RE: Project File Number, Brown and Jackson, SE-20-00003

Our written comments submitted are in regard to Washington State Environmental Policy Act (SEPA), Chapter 43.21C RCW, and Kittitas County Grading Permit public notice Brown and Jackson, SE-20-00003, dated, Monday, August 17, 2020. It is of our understanding that Kittitas County is acting as SEPA Lead Agency for the proposed project and proposed SEPA project actions and that Kittitas County is reviewing Brown and Jackson's June 11, 2020 Kittitas County, Department of Public Works, Grading Permit Application. However, based on review of the documents we understand we are commenting on the project as a whole, including, but not limited to, SEPA determination for Washington State Department of Ecology's General Permit for Biosolids Management.

Attachment 1: Surface Water Resources

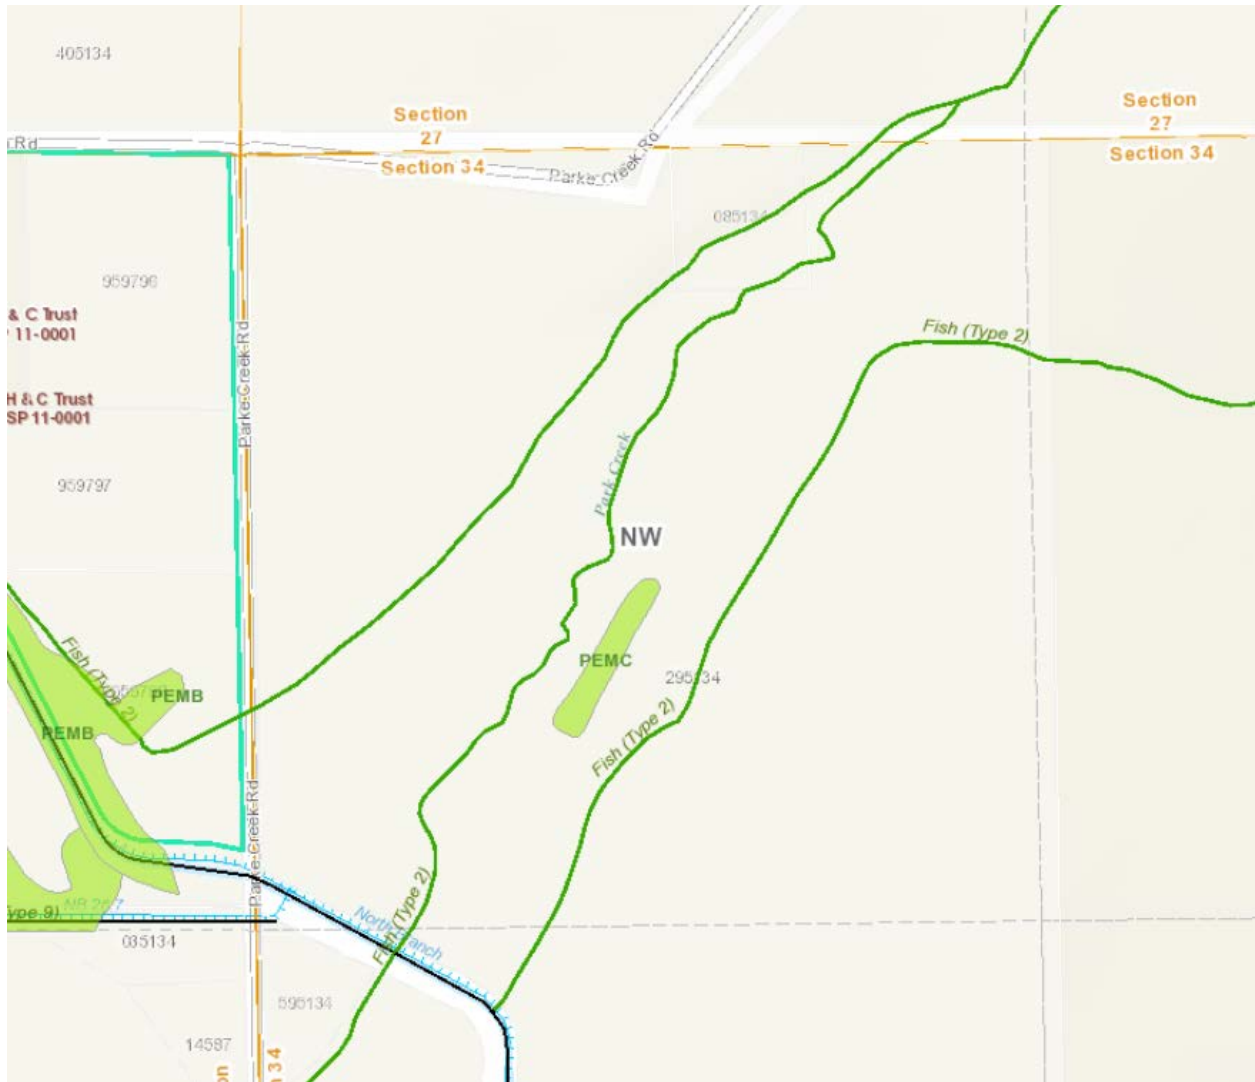
A.12.: Included Preliminary Site Plan does not appear to locate features, such as streams and irrigation ditches accurately. Included map in the July 30, 2020 Western Pacific Engineering and Survey document improperly characterizes Parke Creek’s location with respect to the fields and proposed storage ponds. Parke Creek is the water body flowing from the north to south on the eastern-center portion of the site. The irrigation ditch, locally known as Parke Creek Ditch, flows from the east to the west across the site conveying irrigation and stock water to farms and ranches several miles downstream of the site. Please update maps and labeling.

A.1.: Parke Creek Ditch flows east to west diagonally across the project site. Parke Creek flows north to south across the project site. KRD North Branch Canal immediately abuts the project site to the south. 3 surface water bodies, total. Please update.

Corrections to the map are included in Attachment 1.
